Subject: MHI's Response to US-APWR DCD RAI No. 1035-7064 (SRP 05.04.07)

Response to Request for Additional Information No. 1035-7064

RAI NO.: NO. 1035-7064
SRP SECTION: 05.04.07-Residual Heat Removal (RHR) System
APPLICATION SECTION: 5.4.7
DATE OF RAI ISSUE: 05/20/2013

QUESTION NO.05.04.07-17:

Figure 1 RCS Temperature Transient Curve (Safe Shutdown)

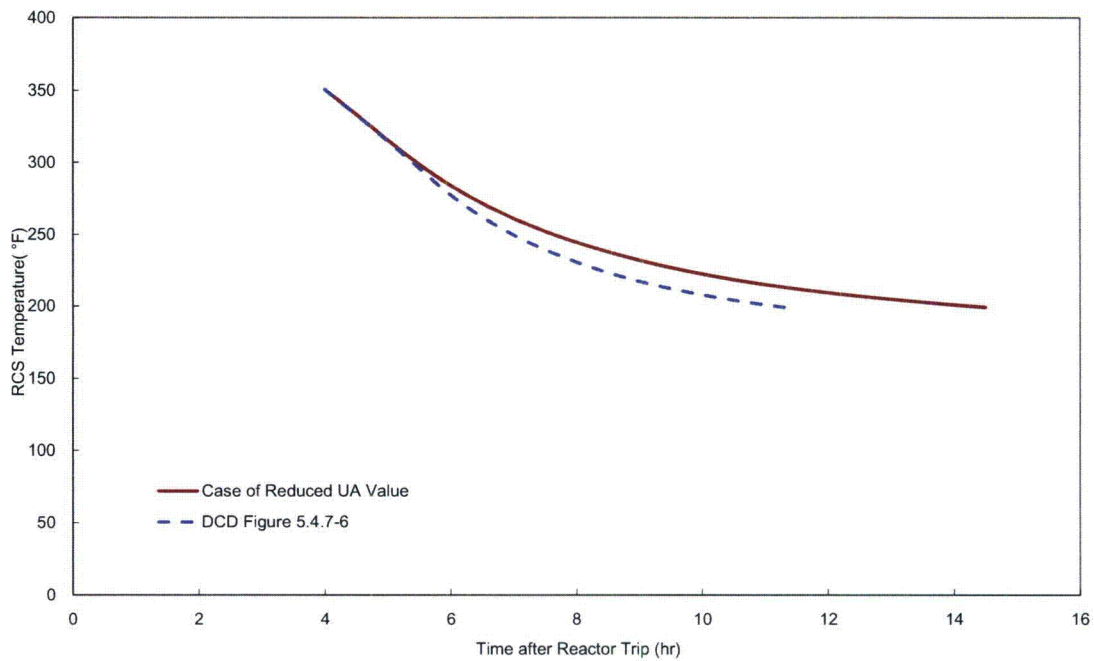
1. What decay heat curve, and associated uncertainty, is used to determine the normal operation and safe plant shutdown temperatures and times in DCD Section 5.4.7.1?
 2. Using the decay heat curve from question 1, calculate the minimum heat transfer rate needed to achieve the normal operation and safe plant shutdown temperatures and times given in DCD Section 5.4.7.1. How does the calculated heat transfer rate compare to that given DCD Table 5.4.7-2 including the effects of the assumed fouling factor given in your response to RAI 6540, Question 6.2.1-24.
 3. Provide a basis for the shell and tube side fouling factors used. Due to the random nature of fouling over time what other conservatisms, if any, are including in the CS/RHR heat exchanger heat removal capability?
-

In Part 3 of this RAI response it will be demonstrated that, even if the fouling factor doubles to $0.001 \text{ h ft}^2\text{F/Btu}$, the criteria for safe shutdown can still be achieved (RCS temperature reduced to 200 deg F within 36 hours of reactor trip). Normal shutdown criteria are not considered in this analysis since abnormal heat exchanger performance degradation would impact the plant refueling schedule which is a non-safety related criterion of the RHRS.

3. As described in the response to RAI 06.02.01-20, RAI 623-4942, UAP-HF-10261, the assumed, tabulated fouling factors are based on values given by Tubular Exchanger Manufacturers Association (TEMA) standards. Since the water chemistries of the tube side (RHRS RCS Water) and the shell side (CCWS) are both administratively controlled and reasonably expected to contain minimal contaminants, this value is selected for both the tube and shell sides of the heat exchangers. In the unlikely event that the fouling factor exceeds the assumed value over the plant life, it would not immediately impact the safe shutdown capability of the RHRS. If the fouling factor is assumed to become double the tabulated value ($0.001 \text{ h ft}^2\text{F/Btu}$), the UA value is calculated to decrease approximately 30% from the design basis value which is based on a generic RHR heat exchanger (since a heat exchanger vendor has not been selected at this time). Assuming a 30% decrease of the UA value, the cool-down performance during safe shutdown for the US-APWR is demonstrated in Figure 1. As shown in Figure 1, in the case of the decreased UA, the safe shutdown criteria are still achieved (safe shutdown within 36 hours and RCS temperature below 200 deg F). Therefore, in addition to consideration of the listed fouling factors in Table 5.4.7-2, should an unexpected rate of fouling occur in the tube and shell sides of the CS/RHR heat exchangers, sufficient margin is also built into the design basis UA specification of the CS/RHR heat exchanger to account for any uncertainties as demonstrated by the preceding analysis. Discussion of this analysis in the DCD will be included as part of the DCD mark-ups for the response to RAI 1036-7079.
